Office Action Summary

10/625,160

KEH ET AL.

DETAILED ACTION

Figure 1 of Ohta.

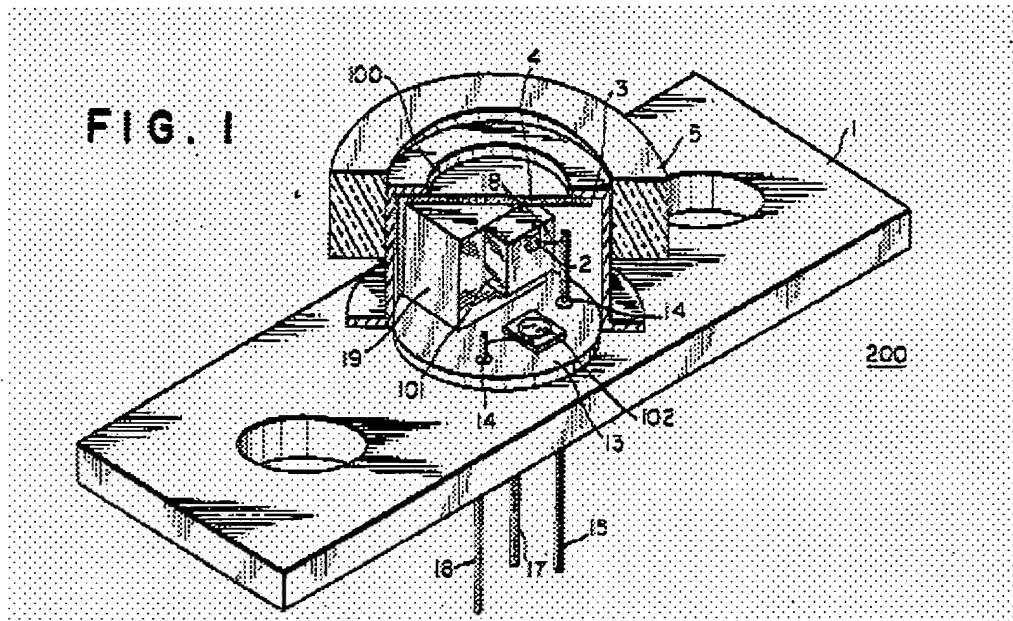
Regarding claim 1, Ohta discloses an optical module comprising:

a stem (1 and/or 13);

a silicon optical bench (101) disposed on the stem,

a laser diode (2) disposed in/on the silicon bench (101);

a photo diode (102) disposed in/on the stem, the photo diode (102) converts light received from the laser diode into current (col. 4, lines 25-30);

and a plurality of leads (15-17) coupled to the stem. See Figure 1 of Ohta reproduced below.

Thus, Ohta only differs from claim 1 in that Ohta does not teach that his silicon optical bench (101) has a V-groove, with the laser diode (2) disposed in or on the V-groove.

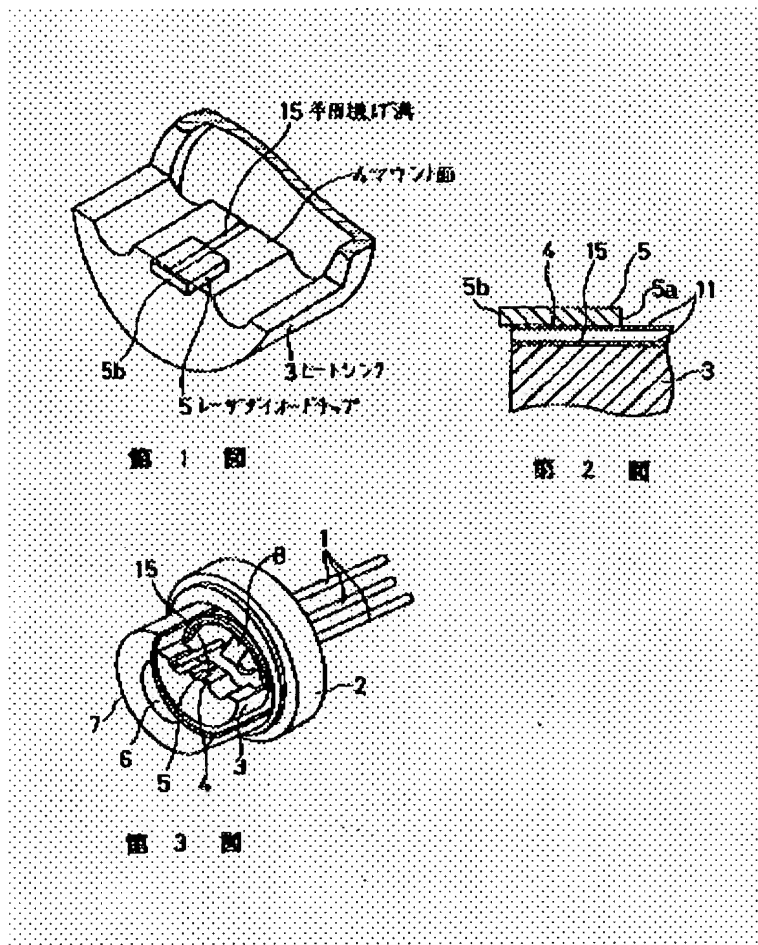
Toshiba (see Figures 1-3 below) teaches providing a groove (15) in a heat sink (3) and disposing a laser diode (5) on the groove. The silicon bench of Ohta is also used as a heat sink (see Ohta at col. 4, ll. 17-18).

The configuration of disposing a laser diode on a groove is useful for providing a solder dam in the Toshiba reference. It is further noted that forming V-grooves in silicon benches was a well-known conventional technique at the time of the claimed invention. See Patent No. 6,733,190 to Kuhara et al. at column 19, lines 12-16.

Therefore, it would have been obvious to provide a groove in the silicon bench of Ohta and dispose the laser diode on the groove in view of Toshiba. It would also further been obvious to provide a V-groove in Ohta in view of Kuhara. The above modifications would have provided a

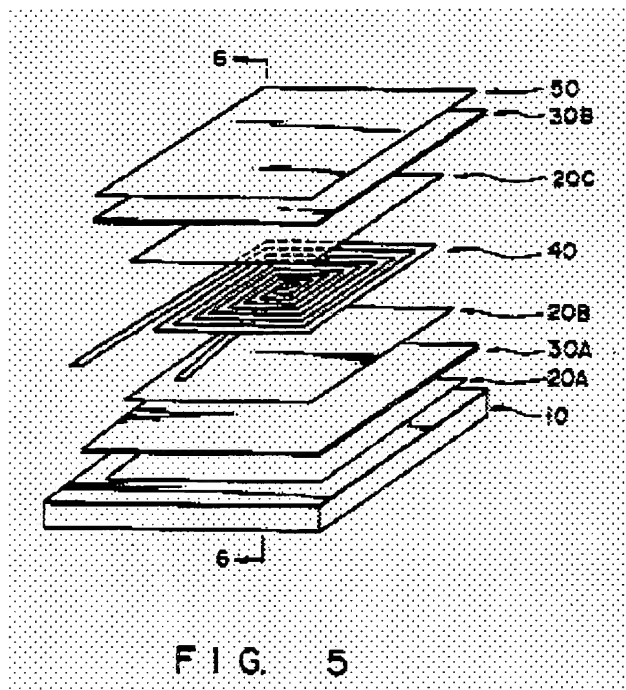
Mizoguchi, however, teaches disposing a spiral type thin film inductor choke coil (40) disposed on a silicon substrate (10). See Figure 5 of Mizoguchi reproduced below.

The inductor coil (40) of Mizoguchi is desirable to use as a DC-DC power converter and for miniaturization of electronic devices. See Mizoguchi at column 5, lines 47-52 and column 6, lines 23-27.

Therefore, it would have been obvious to one of ordinary skill in the art to obtain the invention of claims 2-3 by combining Mizoguchi's spiral thin-film inductor choke coil with Ohta in view of Toshiba and Kuhara.
